DEALER BULLETIN

BULLETIN No; BMW0910

SUBJECT; FLEXIFRAMES

With 'Back Fill Silicone'

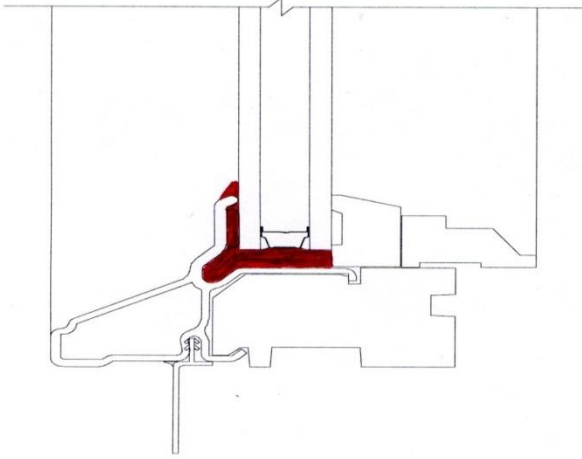
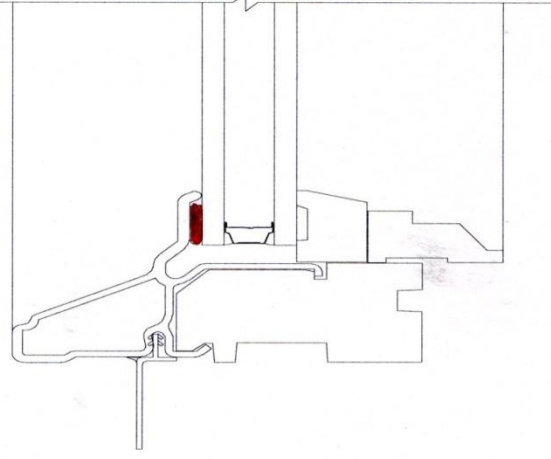
With immediate effect ALL new orders for Flexiframe units will be ordered with 'Back Fill Silicone' to resolve any issues of water penetration in exposed areas and to help overcome any installation issues on larger sized units, where handling could cause a break in the seal.

There old style of silicone fill will no longer be an option.
